PEZ 2017-289: MMC East Tower and Visitor Parking Garage -Site Plan Requirements

The following are my review comments and recommendations on the Site Plan application for the MMC East Tower and Visitor Parking Garage components, touching upon: Bicycle Parking; ADA-Compliance at both locations; and, Street Lighting on Congress Street.

Source: Google Streetview, Aug. 2017.

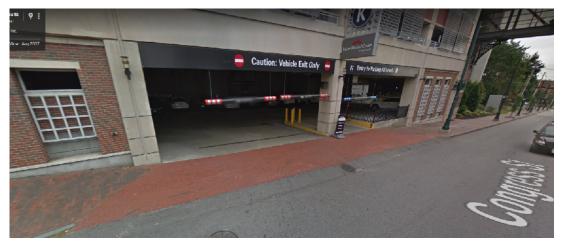
The sidewalks and curb ramps serving crosswalks along the frontage of the East Tower appear to meet ADA-accessibility requirements. The curb ramps on the opposite side of the street do not appear to meet ADA due to what appear to be worn detectable warning panels (being comprised of concrete pavers). The applicant is to assess the condition of the detectable warning panels at each crosswalk serving the East Tower site and replace those that are not compliant due to their condition with cast iron detectable warning panels.
